French Prairie Bridge Project Memorandum

Date: December 5, 2018
To: Project Task Force
From: Project Management Team
RE: Task Force Meeting #4 – Project Update

**French Prairie Bridge Project
Task Force
Meeting Agenda
Wednesday, December 5, 2018
6-9 PM**

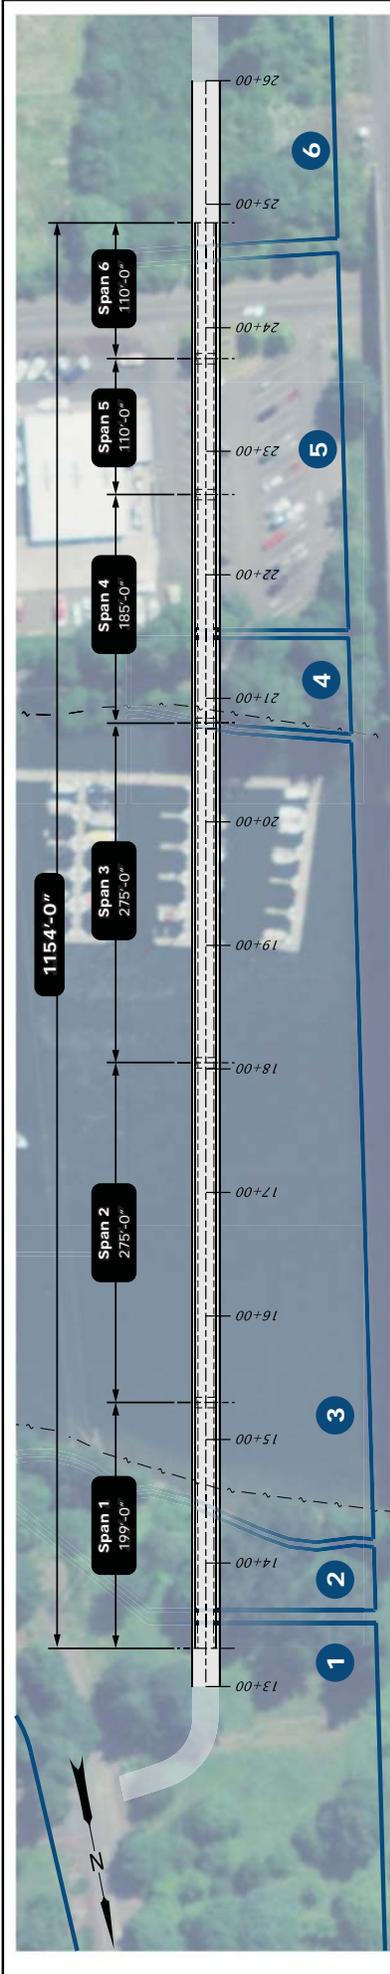
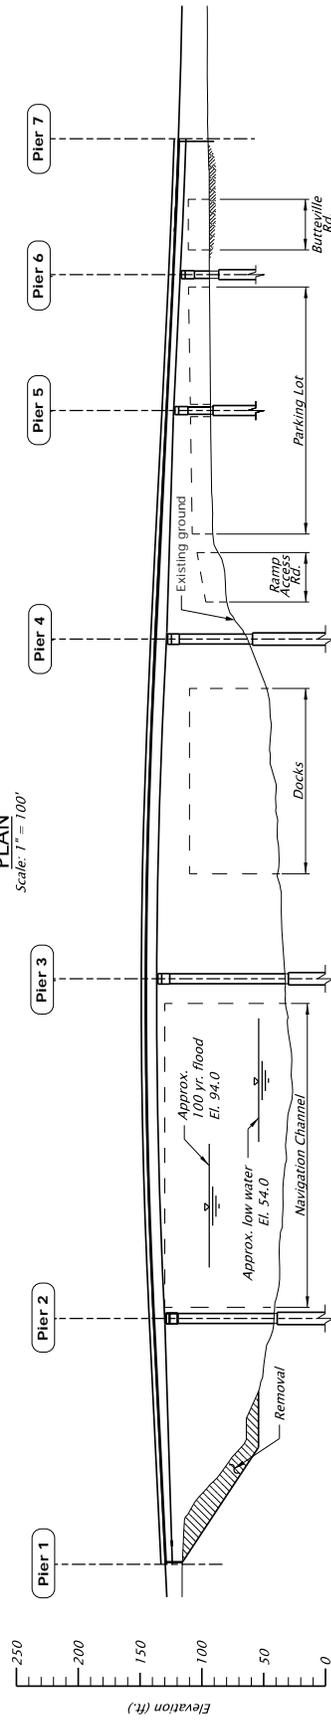
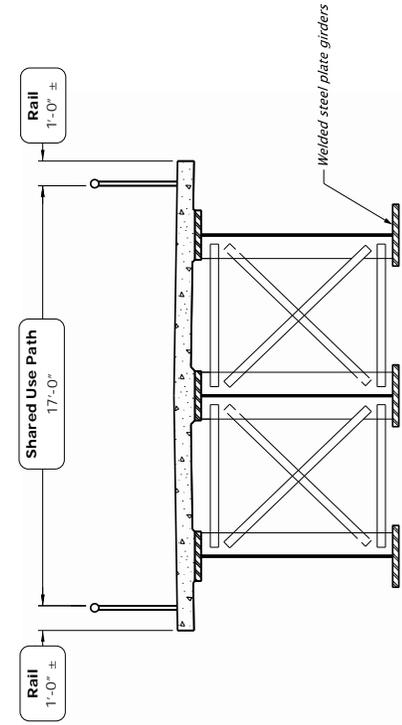
The TAC brought up a concern about excavating the edge of the river versus building a retaining wall, a consideration the project team went back and forth on in terms of showing on the bridge figure. Ultimately, the project team decided to show the bank cut back. It was noted that land could be better utilized with the construction of a retaining wall, but at a higher project cost.

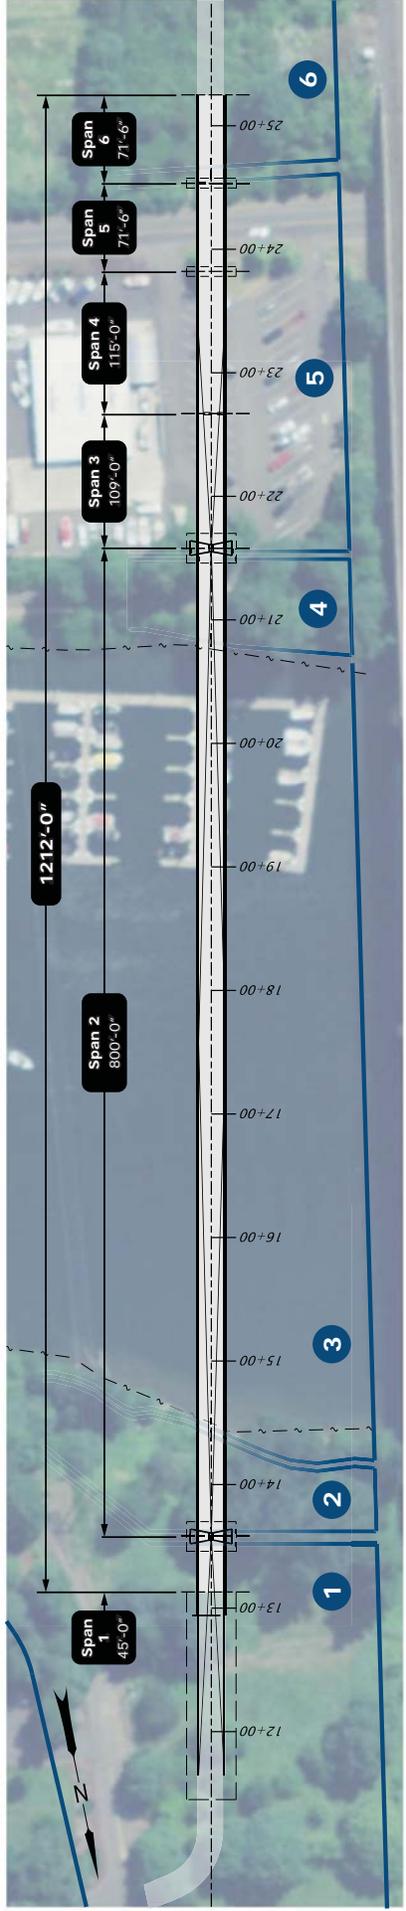
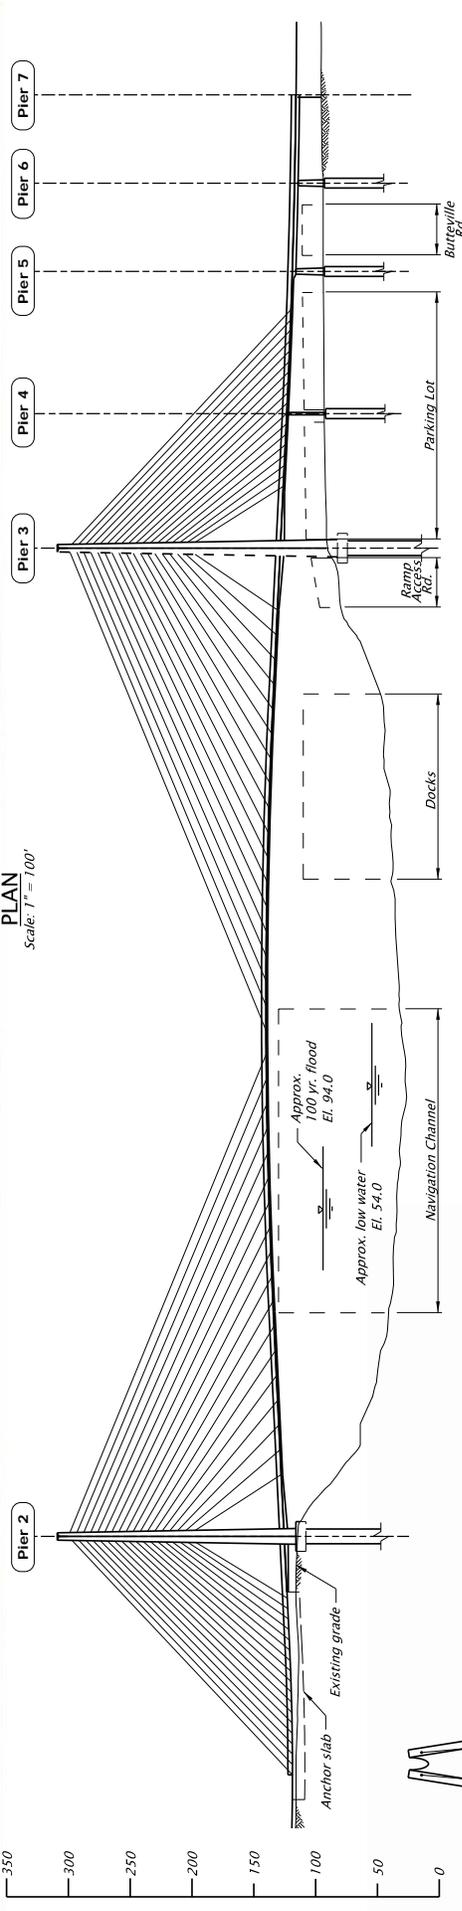
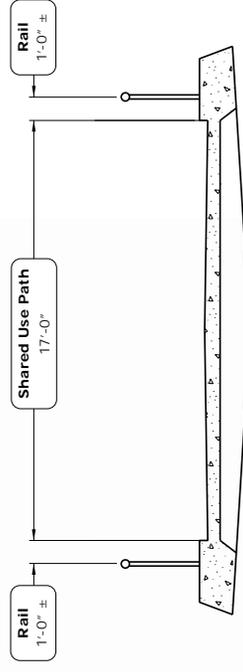
There was discussion about the impacts to the marina's parking lot. This bridge has a potential to impact parking for up to two years of construction and the potential to remove a parking spot for the bridge's foundation. Consideration is needed long term for a new parking lot to serve the trailhead to alleviate stress on marina parking space, one member said. A new lot was not considered in this study since it does not affect bridge type selection.

This bridge type has no piers in the river, which will reduce or eliminate permanent impacts in the river. The bridge figure shows a pier in the parking lot, but the project team says it is possible to remove that pier during preliminary design. This bridge type has the potential for further modifications to reduce temporary and permanent impacts to the marina and river, however, it is a relatively high cost bridge type that requires specialty construction.
